STATE OF WASHINGTON
DEPARTMENT OF ECOLOGY

Re: CONTINGENCY PLANNING AND CORRECTIVE ACTIONS FOR SINGLE SHELL
TANK 241-C-106

COMPARISON OF EVAPORATIVE LOSSES AND WATER ADDITIONS TO 106-C
May 27, 1992

Liquid Level in Tank 106-C

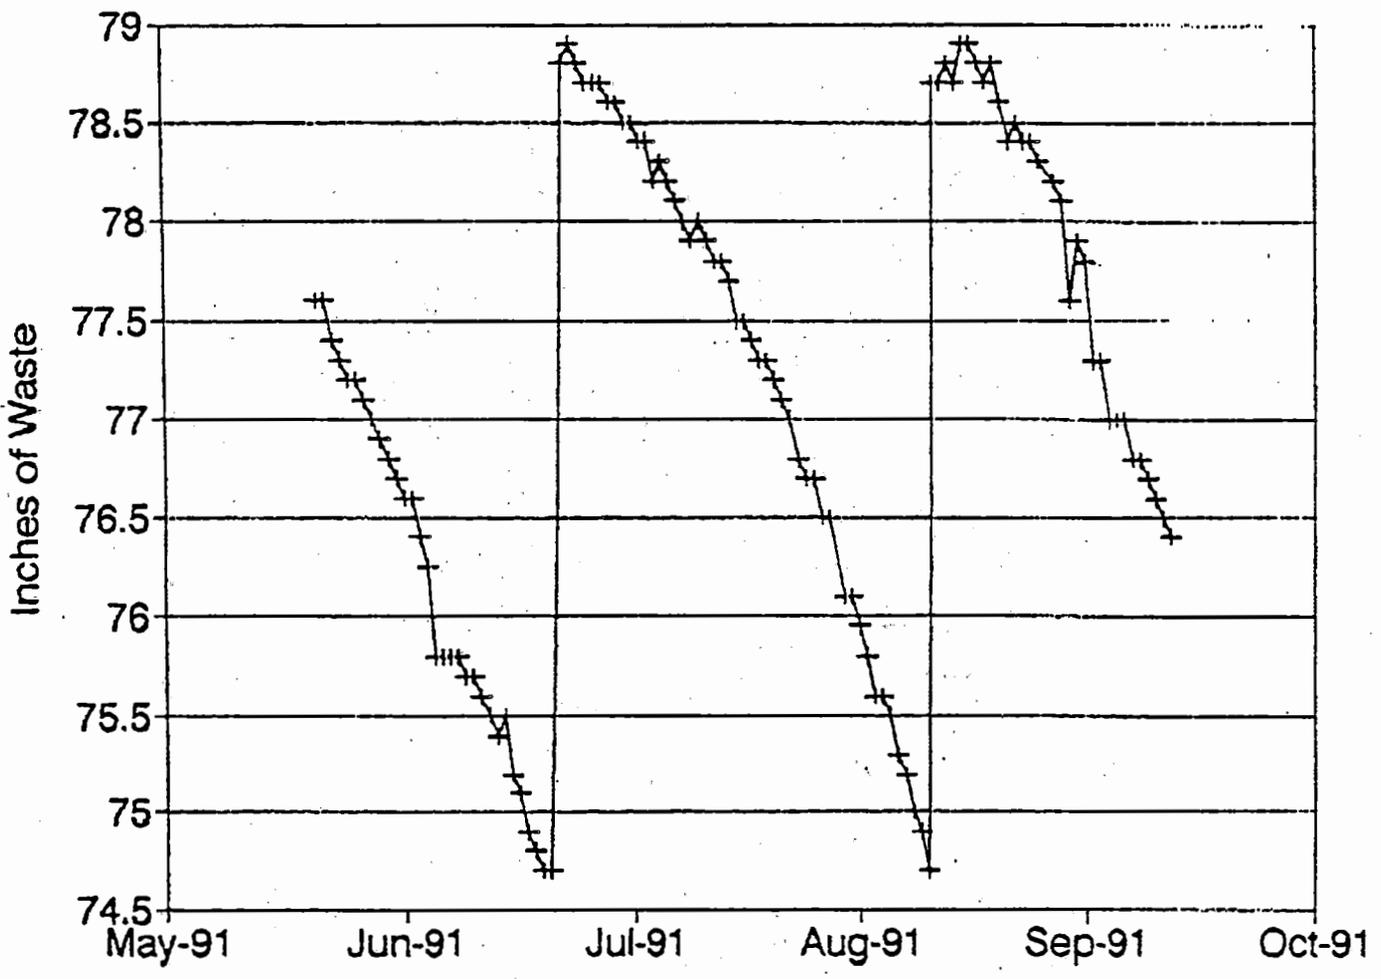
Liquid level measurements in tank 106-C show steady liquid surface decreases of about 230-270 gallons per day, interrupted every 4-8 weeks by batch additions of 6000-12000 gallons of water (see Figure 1). USDOE/WHC has proposed that these liquid level decreases are caused by the evaporation of water due to the high radioactive decay heat in this tank (waste temperatures were reported to be up to 188F on May 23, 1992). USDOE/WHC monitors the water content of air entering and exhausting from tank 106-C. These monthly measurements can be compared to the water addition records to provide indirect leak detection. The amount of water added to the tank should roughly equal the amount of water vapor released to the atmosphere. If not, 106-C may be leaking.

Figure A-3. Tank 106-C Vent System

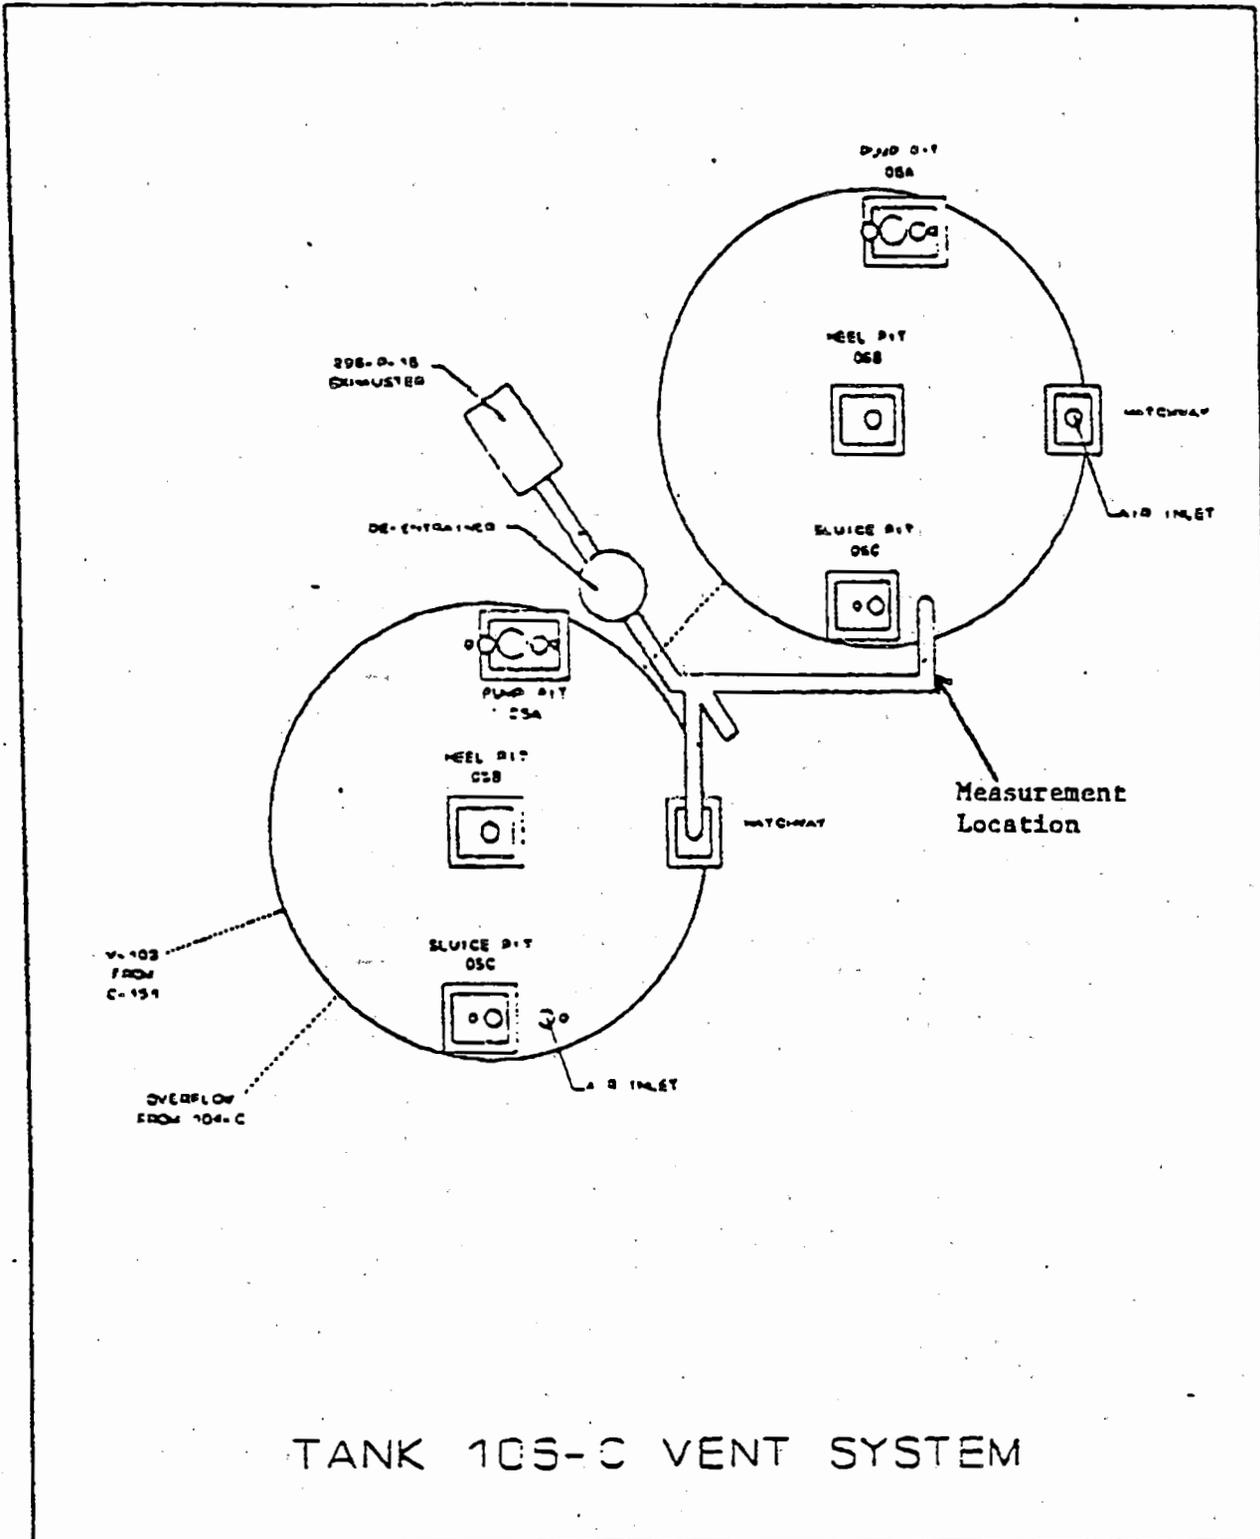
Evaporative losses have been calculated by USDOE/WHC using ambient and exhaust wet and dry bulb temperatures (also called psychrometric data) measured from December 1990 through September 1991. These temperatures are taken monthly at the locations shown in Figure 2, and the results are summarized in Table 1.

- Moist air from 104-C and 105-C enters 106-C through a 3 inch overflow pipe. In addition, condensed vapors from 105-C and 106-C are collected in a deentrainer and returned to 106-C. Both sources of water should be added to the water additions for 106-C. If this were done the discrepancy between water additions and evaporative losses would be greater. The volumes of these sources are not known, and should be measured if possible.

- The effect of the deentrainer on uncondensed vapors is not known. If the deentrainer is causing some water vapor to condense, this would cause evaporative losses to be overestimated (since evaporative losses are measured before the deentrainer) and would increase the observed discrepancy between water additions and evaporative losses.

Tank 106-C Water Balance

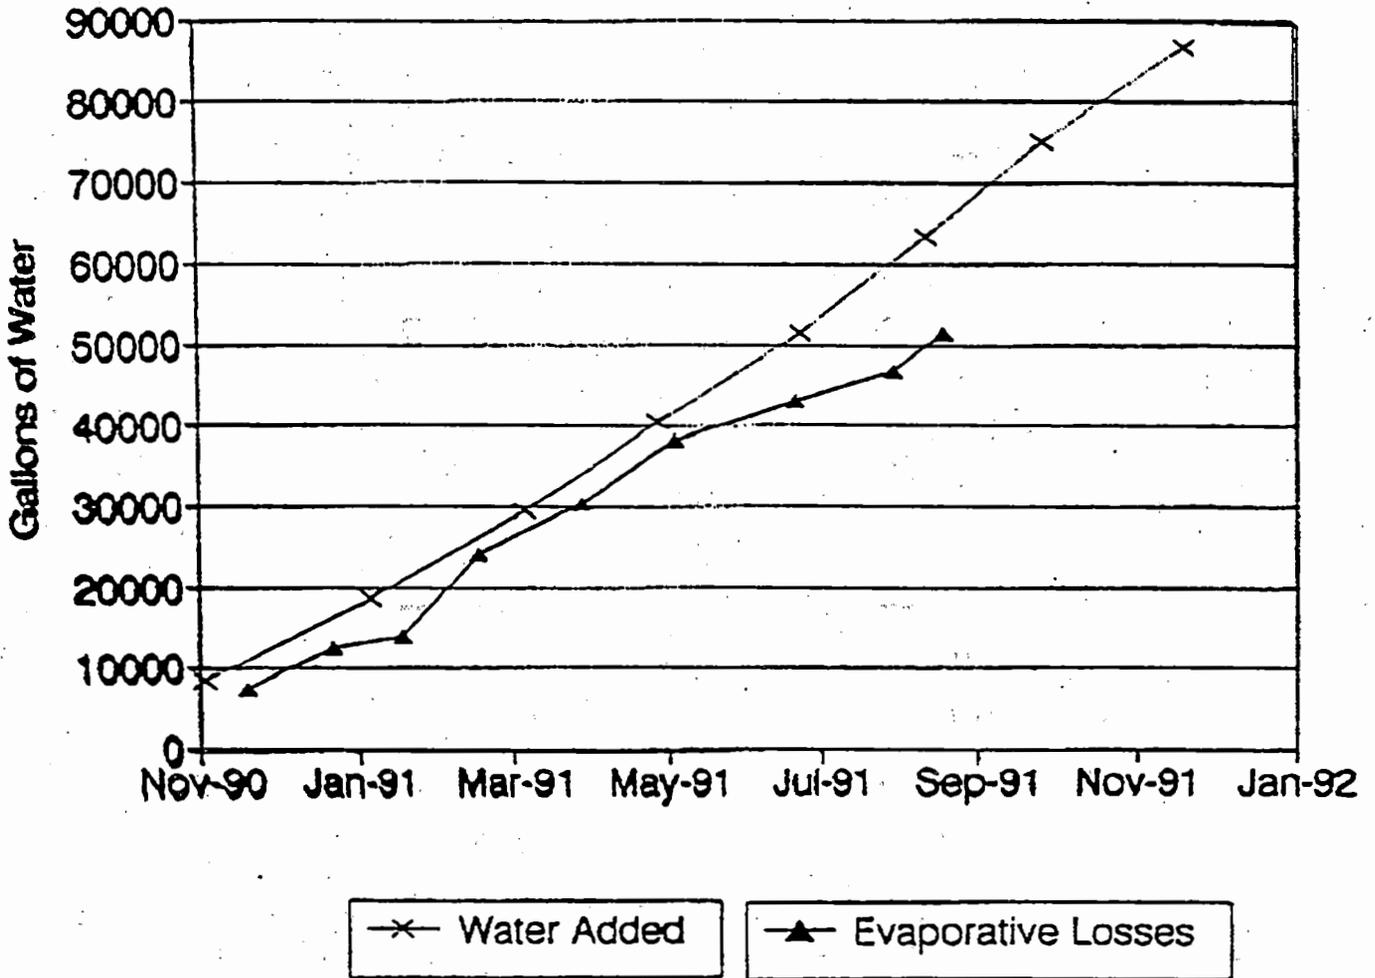
Figure 3 shows cumulative water additions and evaporative losses for November 1990 through December 1991 (Note: Water additions are plotted as a smooth curve though they actually occur in batches). The difference between these two curves indicates water added to the tank but not accounted for in the exhaust vapor. The two curves agree well until May through September 1991 (the last time exhaust vapor was measured) when this cumulative difference grew to about 10000 gallons (more water added to the tank than measured in the exhaust).

The 10000 gallons of unaccounted water may or may not be a significant discrepancy. Water addition data is thought to be very accurate, but calculations of evaporative losses have some unspecified uncertainty associated with them. The error range of the water vapor measurements has not been determined so it is not clear whether the 10000 gallon discrepancy is within measurement error, or whether it represents a leak from the tank.

Until these limitations are quantified (providing an error range for the measurement), or until other more sensitive leak detection methods are proven, a conservative approach would be to consider that 10000 gallons of tank liquids may have leaked from tank 106-C between May and September 1991.
